PRODUCT ADVISORY

Corrections to Standard Microcircuit Drawing 5962-95729 for Intersil Product HCS154*

**Refer to:
PA10091**

Date: September 21, 2010

FIGURE 3. Logic diagram.

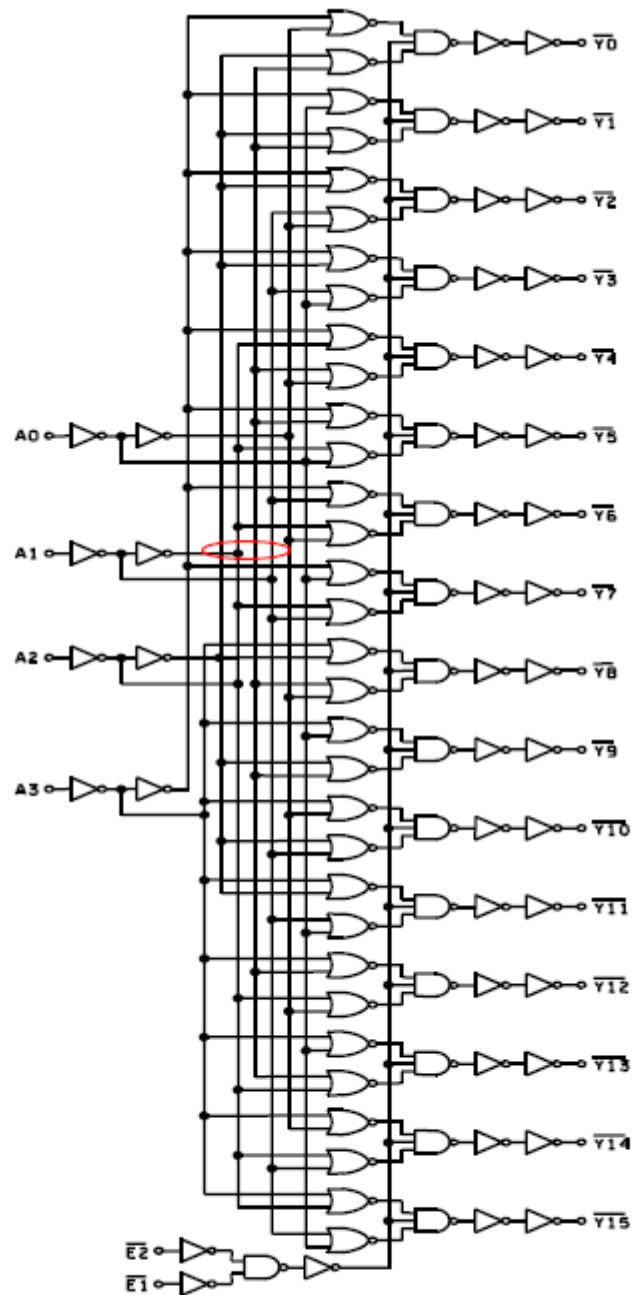
This advisory is to inform you that Intersil has made corrections to DSCC (Defense Supply Center Columbus) SMD (Standard Microcircuit Drawing) 5962-95729 for the HCS154* products. The updates correct errors in the Truth Table (Inputs A0 – A3 were reversed) and Logic Diagram (Input A1 connection). There have been no changes of any type to the screening or product itself. The updates to the DSCC SMD are complete. The released SMD is available on the DSCC website at <http://www.dscclia.mil/downloads/milspec/smd/95729.pdf>.

Incorrect Logic Diagram – PA10091

FIGURE 3. Logic diagram.

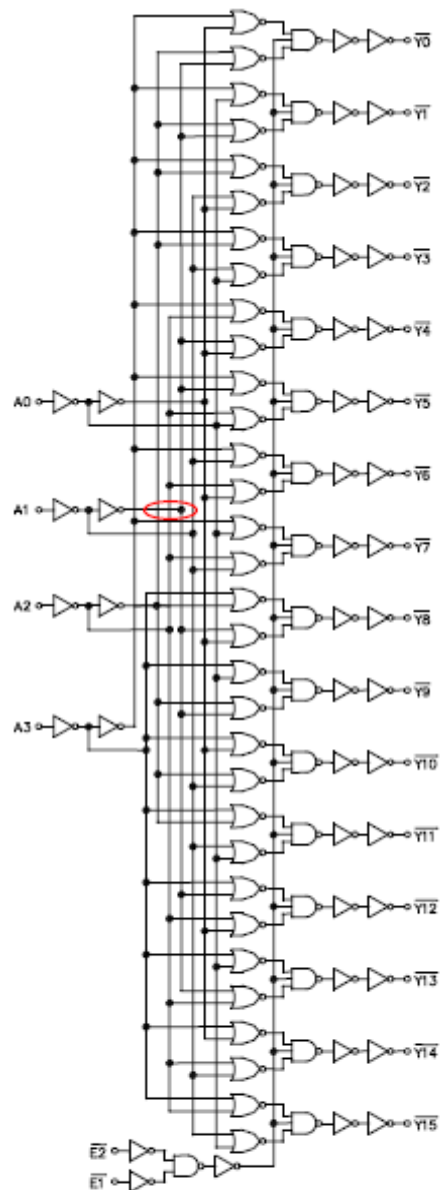
Correct Logic Diagram – PA10091
